ADDENDUM No. 1
Bid Package #1: Construction Documents
Encompass Architects, p.c.

Canopy Row
700 N St., Lincoln, NE 68508
NGC Group

EA Project No.: 16-1100

DATE OF ISSUANCE: February 8, 2017

1 BUILDING C WASTE & VENT RISER DIAGRAM
NO SCALE

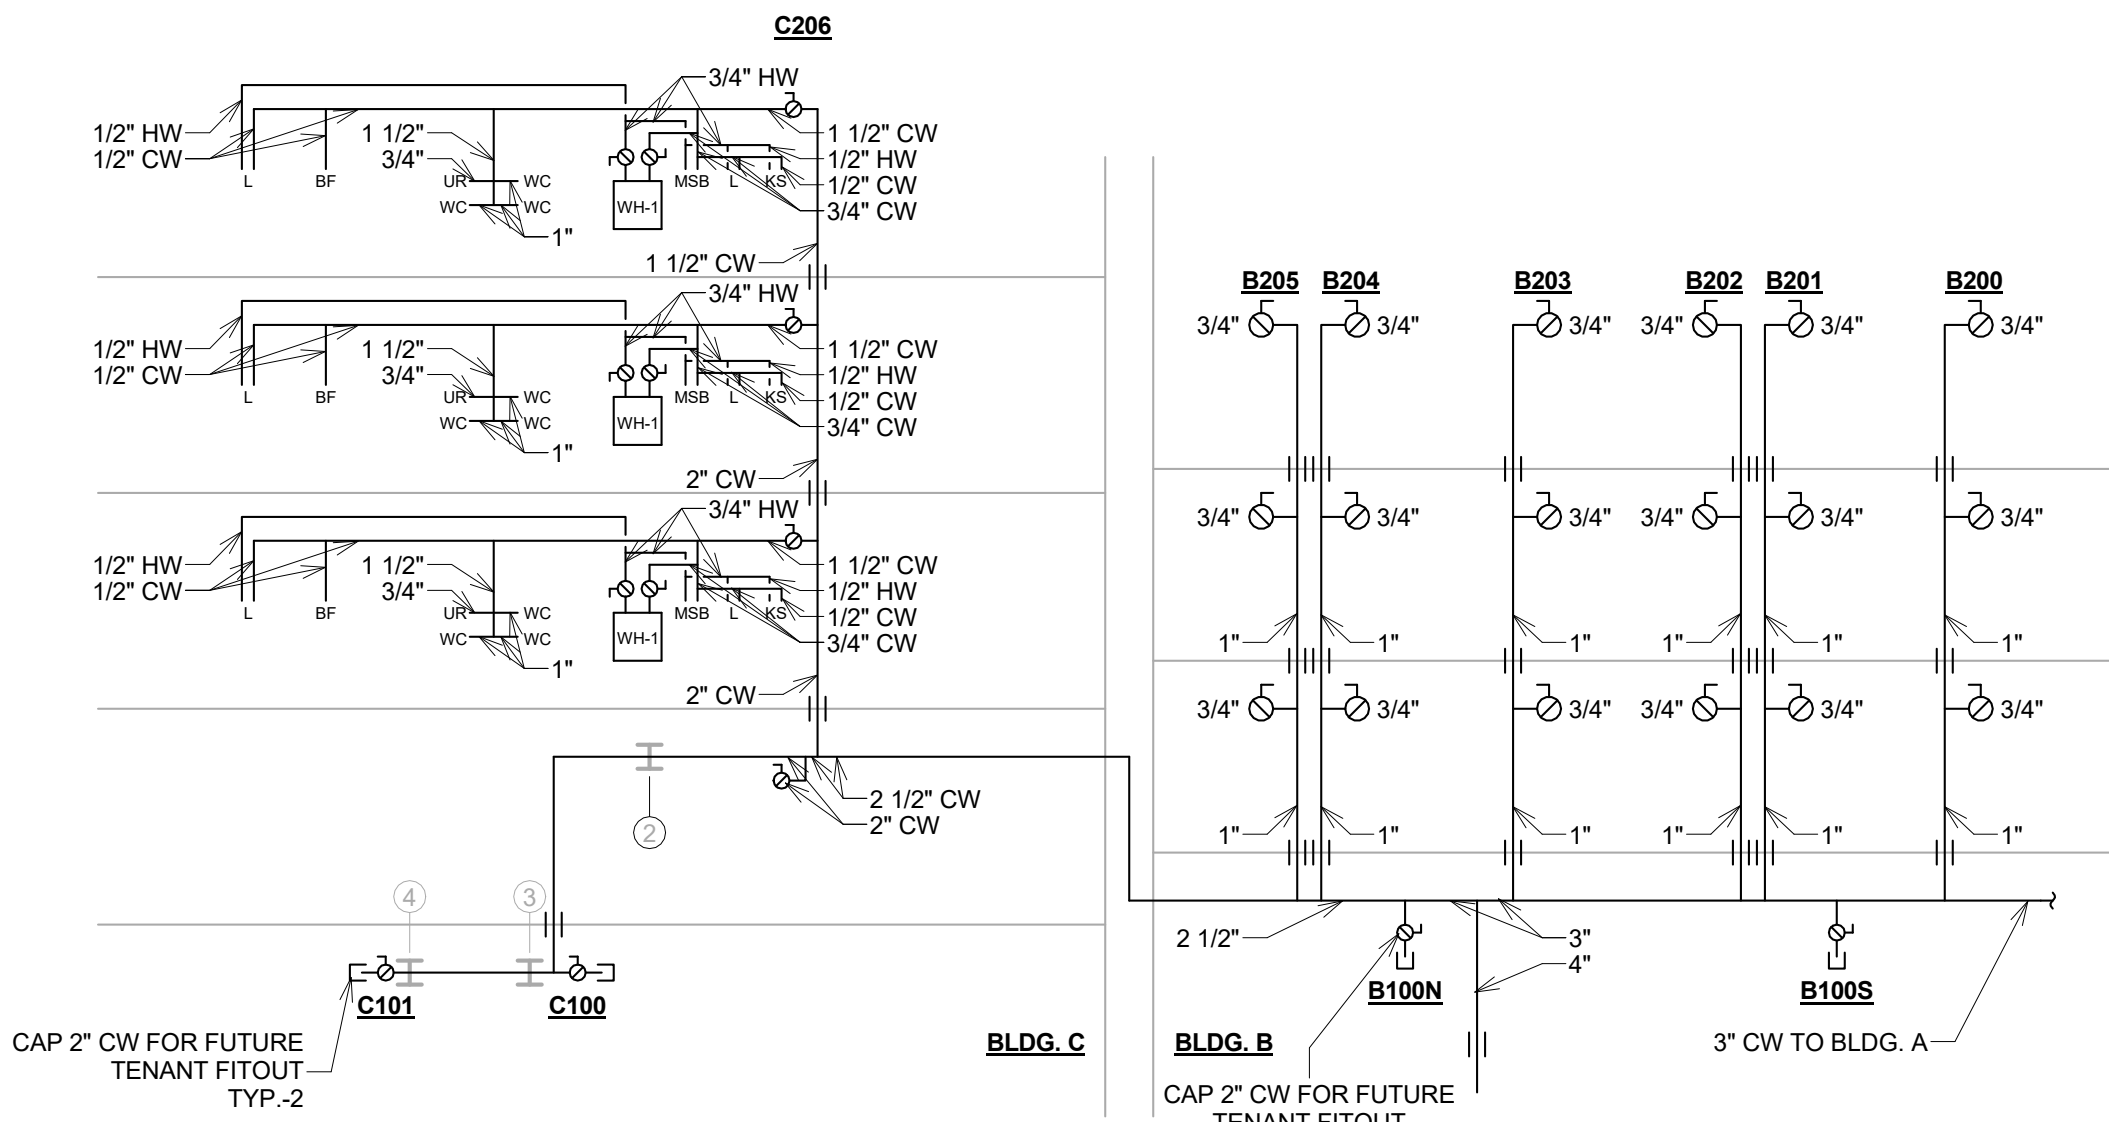
Building C Waste and Vent Riser Diagram: The waste and vent riser diagram was revised to reflect changing the kitchen sinks on second through fifth floor draining to a single waste and vent stack instead of draining to the waste stack in the toilet chase on each floor.

RISER DIAGRAMS-AREA C.
ADDENDUM 1: CHANGE W & V RISER DIAGRAM (DETAIL 1) TO HAVE KS ON ITS OWN
RISER (W CONNECTING TO THE MAIN ON 1ST FLOOR & V CONNECTING TO THE MAIN AT
THE BATHROOM CHASE ON 5TH FLOOR)

SITE PLAN - ELECTRICAL

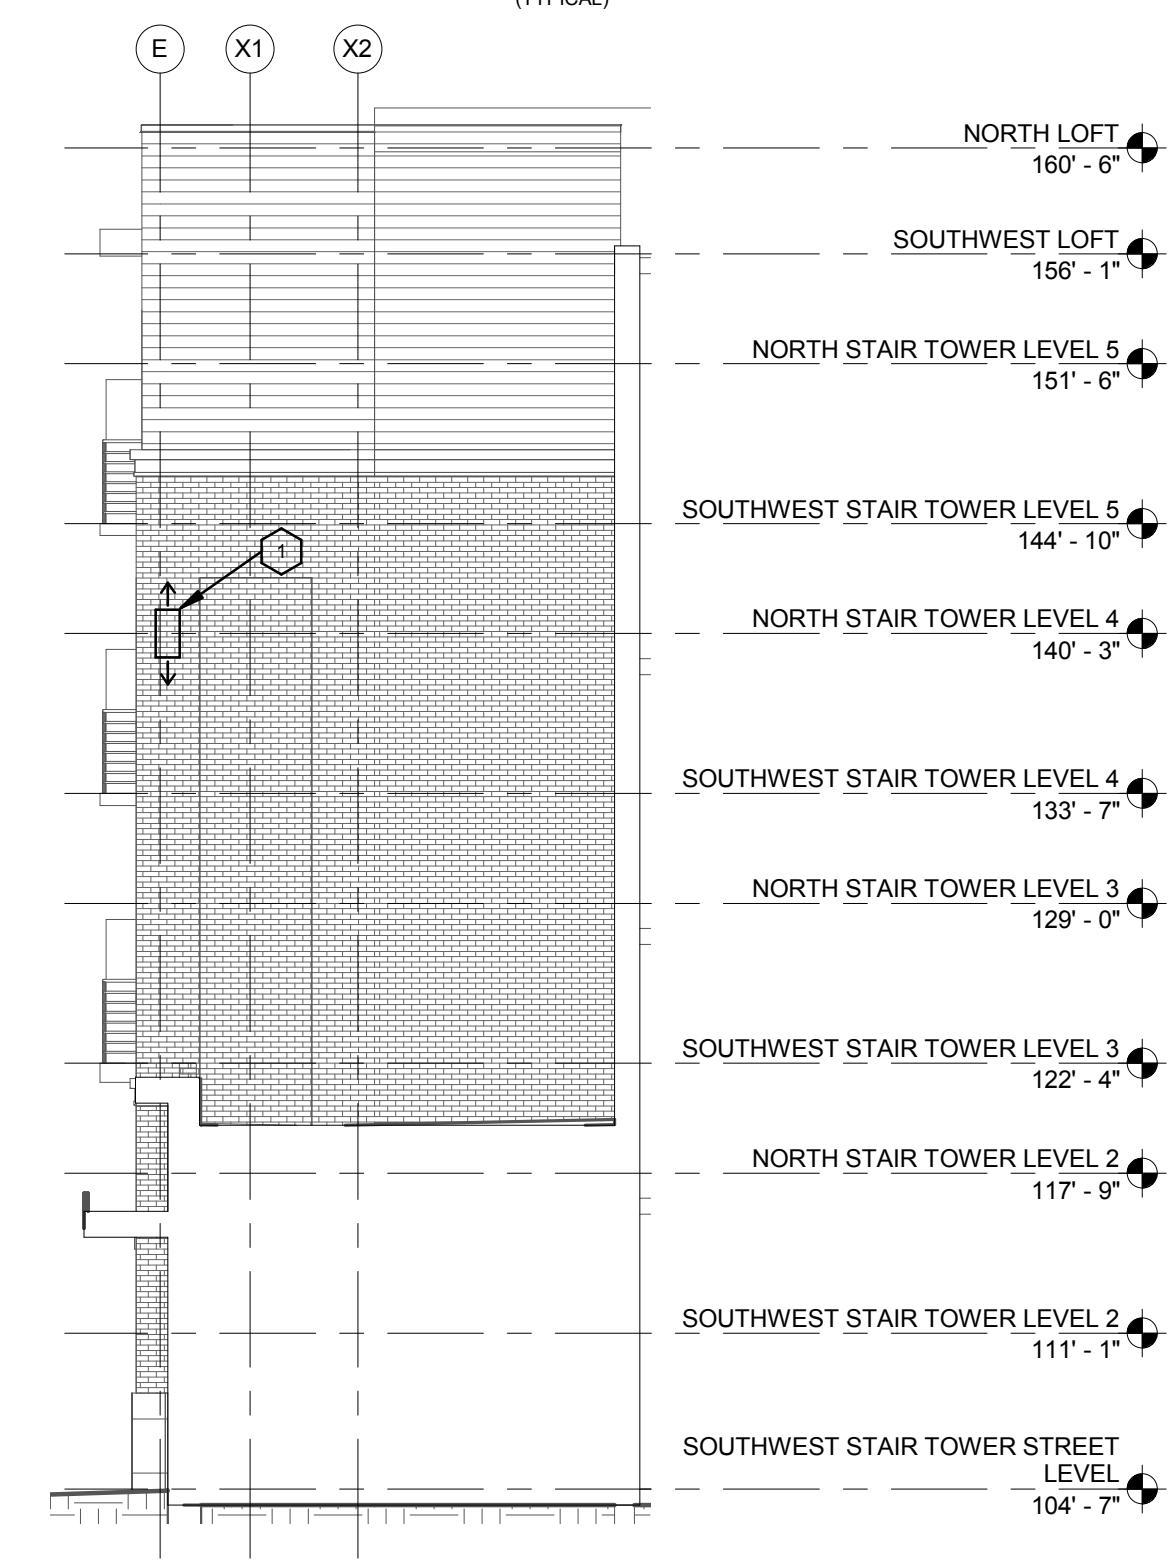
1. Sheet E100 Site Plan Electrical
 - A. This sheet shall be included in the bid package. Include all work on this sheet in the bids.
 - B. The two new LES transformers shall be switched. The smaller, Parking Garage, transformer shall be located north of the Canopy Row transformer. See the attached sheet.

- C. There is an existing pole light on the west side of the existing outdoor parking lot that shall be removed and relocated to the east side of the existing parking lot. Remove existing pole and relocate pole and circuit to the east side of the parking lot. Provide a new concrete base for pole light. See Civil Drawings for new location.

- D. Due to the number of bends in the Secondary Electrical runs the Contractor shall install the Secondary Electrical Conductors where indicated on the attached LES Drawing UC-C-SHT 1 of 1, LES will supply the conductors but the Contractor shall install them.
